# Dunkellin River and Aggard Stream Flood Relief Scheme

## Response to Iarnród Éireann

Client:	Galway County Council
Project Title:	Dunkellin River and Aggard Stream Flood Relief Scheme
Document Title:	Response to Iarnród Éireann
Document No:	MGE0260RP0020

**Figure 2.1 – Map of Site Investigation Works**

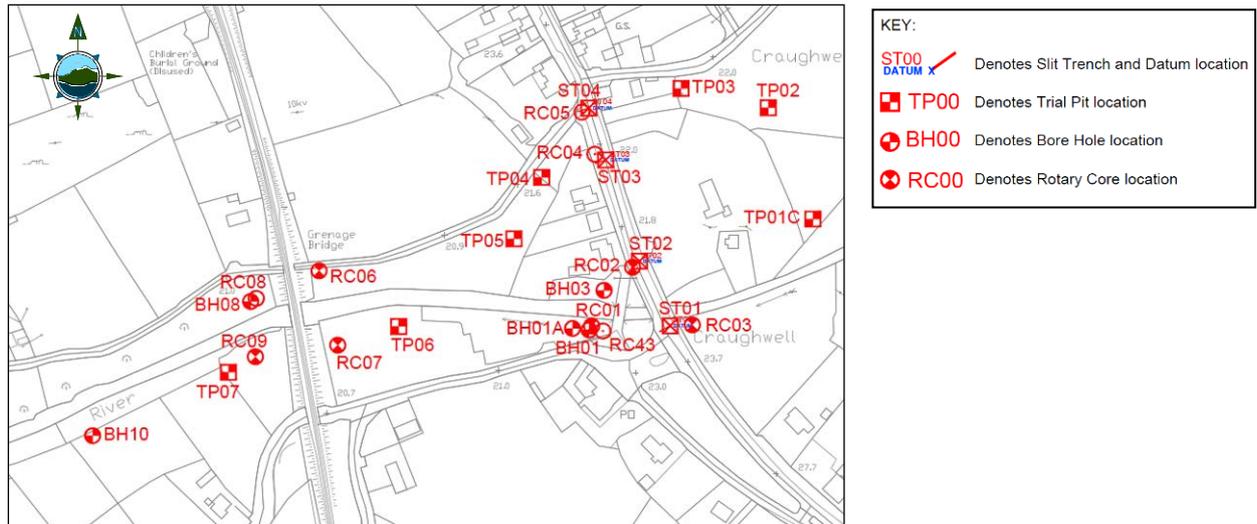
**2.3** *Drg. No. 6408-2210 Rev C: The proposed works to the railway bridge indicate that anchored mini-pile underpinning is to be provided to the base of the existing abutment however no site investigations have been carried out to determine the detail of the existing foundations of UBE154. In addition, the bedrock nature (i.e. depth to bedrock and competency of bedrock, likely to be strongly weathered, solutionised karst limestone bedrock) needs to be assessed in order to design the depth of mini-piles and the anchorage of the proposed piled wall. In order to properly review the proposed works it is recommended that site investigations are undertaken to determine the full extents of the existing abutment foundations.*

Site investigative works were carried out between August and October 2014 to facilitate the detailed design.

The following **Figure 2.1** illustrates the extent of site investigation which has been completed to date.

The investigations undertaken at the bridge include:

1. Rotary Core 6 (RC06)  
Rotary Core 7 (RC07)  
Rotary Core 8 (RC08)  
Rotary Core 9 (RC09)
  2. Trial Pit 06 (TP06)  
Trial Pit 07 (TP07)
- and
3. Borehole 08 (BH08)
